**PLANNED UNIT DEVELOPMENT
& SUBDIVISION STAFF REPORT****Date: May 6, 2010**

<u>DEVELOPMENT NAME</u>	Apostolic Overcoming Holy Church of God
<u>SUBDIVISION NAME</u>	Apostolic Overcoming Holy Church of God Subdivision
<u>LOCATION</u>	2257 St. Stephens Road (Southwest corner of St. Stephens Road and Allison Street, extending to the Northwest corner of St. Stephens Road and Vetter Street; and Northeast corner of Dickens Avenue and St. Stephens Road)
<u>CITY COUNCIL DISTRICT</u>	District 2
<u>AREA OF PROPERTY</u>	1 Lot / 0.4 ± Acres and 1 Lot / 2.8± Acres
<u>CONTEMPLATED USE</u>	Planned Unit Development Approval to allow multiple buildings on a single building site with off-site parking, and Subdivision approval to create 1 lot.
<u>TIME SCHEDULE FOR DEVELOPMENT</u>	2 to 4 months after approval
<u>ENGINEERING COMMENTS</u>	Need to dedicate to the City a radius of 25' at the corner of Dickens Ln & St Stephens Rd. Must comply with all storm water and flood control ordinances. The construction of any new dumpster pads will require connection to sanitary sewer, cannot discharge to storm sewer. Any work performed in the right of way will require a right of way permit.

SITE PLAN

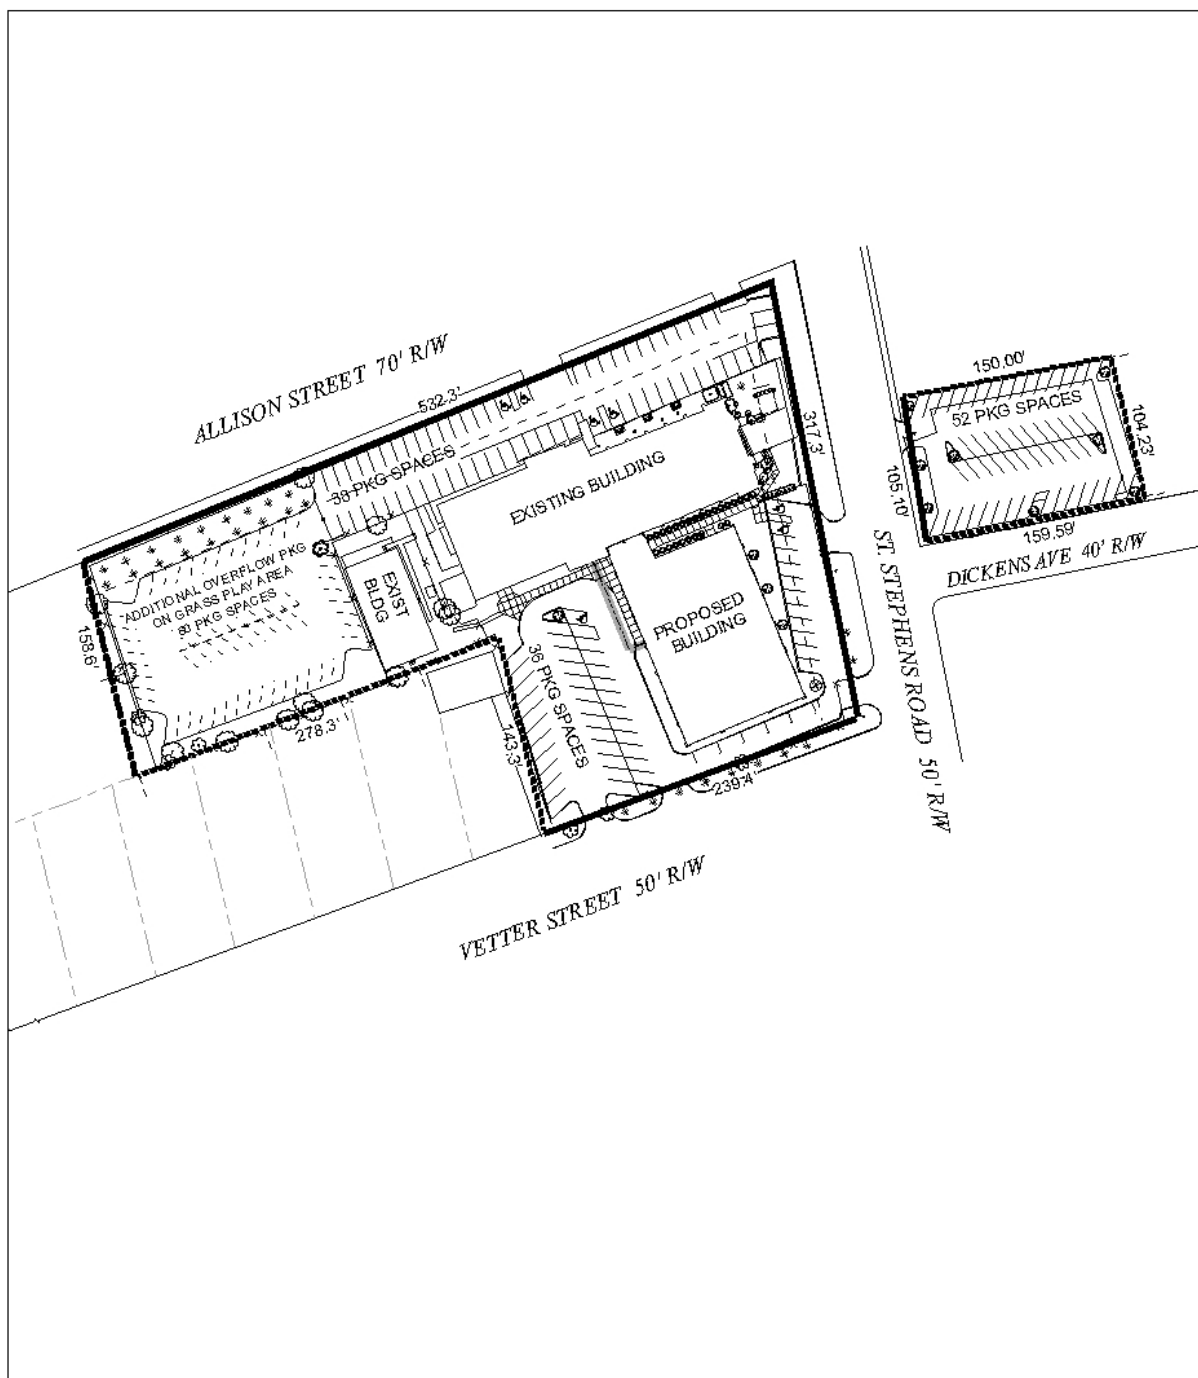
As proposed, the new site plan has several problems: Traffic Engineering has indicated that the revised paved parking area on the main site has circulation and parking space size/location issues. The proposed paved parking area must depict one way circulation, aisles must be narrowed to discourage two-way traffic, parallel parking spaces must be enlarged to meet minimum standards, an entrance may need to be removed, and several parking spaces may need to be removed to provide adequate circulation. Staff also points out that the utilization of a grass surface for required parking has generally not been allowed by the Board of Adjustment. Finally, it appears that both the proposed grass parking area and the expanded parking lot across St. Stephens Road are designed for one-way use, however, the design creates circulation conflict between incoming and exiting traffic: the circulation patterns should be reversed.

Staff cannot determine if the site, as proposed, will comply with the tree and landscaping requirements of the Zoning Ordinance. Each lot must separately comply with the requirements, and insufficient information has been provided to staff to make such a determination. It is clear, however, that the parking lot across St. Stephens Road lacks adequate frontage overstory trees.

No dumpster is depicted on the site plan. If a dumpster is proposed, it should be depicted on the site plan, or a statement should be provided indicating that no dumpster will be included as part of the development.

The Subdivision site, across St. Stephens Road (which is also part of the US Highway 45 system), should be limited to one curb-cut, with the size, design and location of the curb-cut to be approved by Traffic Engineering and ALDOT, and to conform to AASHTO standards.

- 1) Depict all parking areas as paved, with storm water detention if required;
- 2) Revise the parking layout to meet the requirements of Traffic Engineering, including the closing of curb-cuts, and to ensure that parking circulation minimizes traffic conflicts as discussed in the report;

- 3) Consult with Traffic Engineering and ALDOT to determine if the delineation of crosswalks is possible across St. Stephens Road, and revision of the site plan to depict crosswalks if determined feasible;

- 5) Revise the site plan to depict a 6-foot high wooden privacy fence where the site abuts residentially-zoned property, except within the 25-foot street-side setback, where the fence shall only be 3-feet in height;

- 6) Revise the site plan to depict and quantify tree and landscape compliance for each site separately, including the identification of existing trees from the previously approved tree and landscape plan;

- 7) Revise the site plan to indicate if a dumpster will be provided;
- 8) Revise the site plan to comply with the lighting requirements of Section 64-6.A.3.c. of the Zoning Ordinance, and placement of the following as a note on the site plan: *"lighting shall be provided and maintained during the operation of the parking area, and shall be so arranged that the source of light does not shine directly into adjacent residential properties or into traffic."*
